MODIFICATION RECOMMENDED

N5222AS-01A

S E R V I C E N O T E

N5222AS PNA Series Microwave Network Analyzers

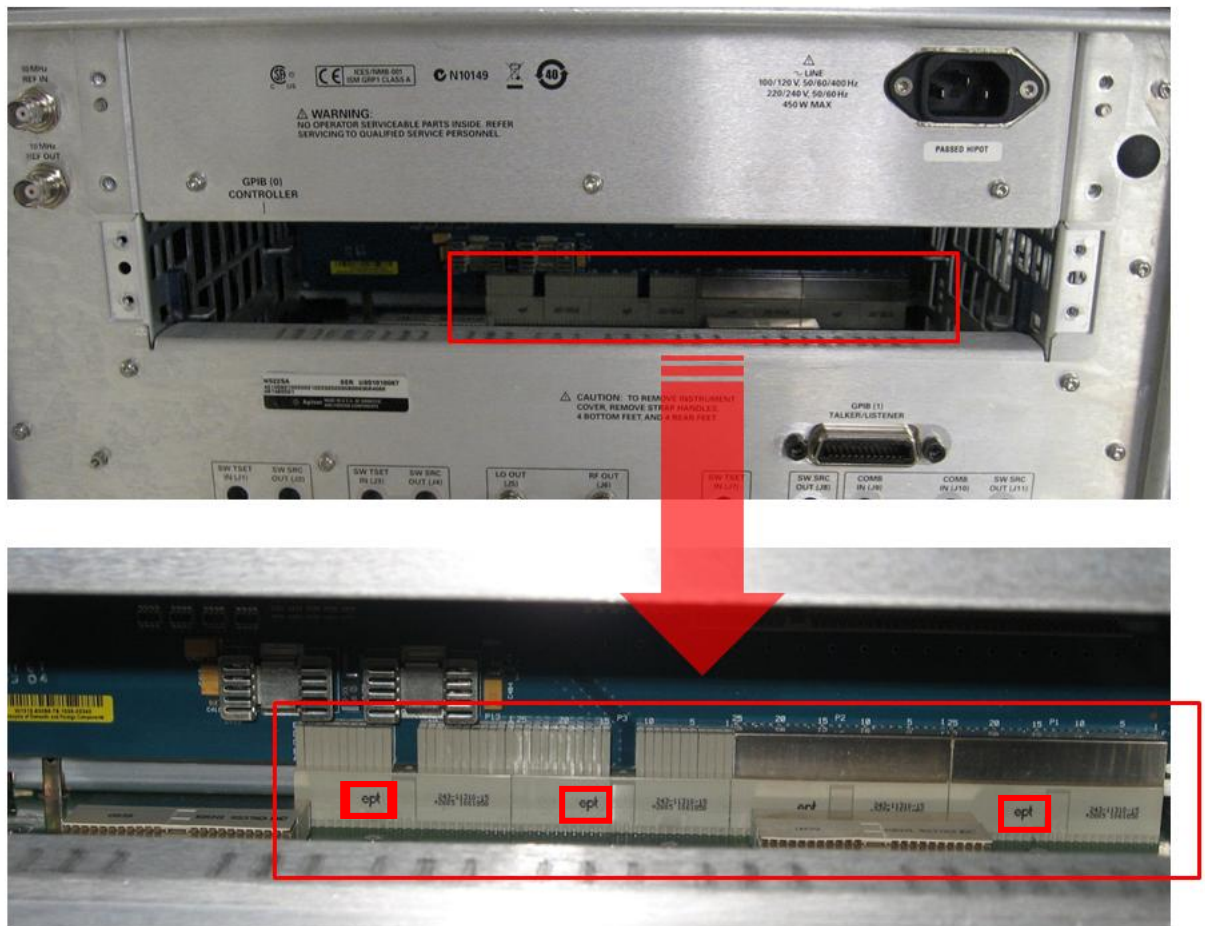
1. Remove the CPU assembly from the analyzer's rear panel. Refer to the PNA Service Guide chapter 7 section titled, "Removing and Replacing the CPU Board Assembly" for removal and reinstallation procedures. To view the online Service Guide, see the numbered list on the next page for instructions.
2. As per the photo below, inspect the system motherboard connector to see if it has one or more "ept" logos.

3. If the connector has one or more “ept” logos, return the analyzer to Agilent for replacement of the system motherboard. If the connector does not have one or more “ept” logos, email ctd-soco_support@agilent.com, providing the analyzer model and serial number and details of the malfunction symptoms.
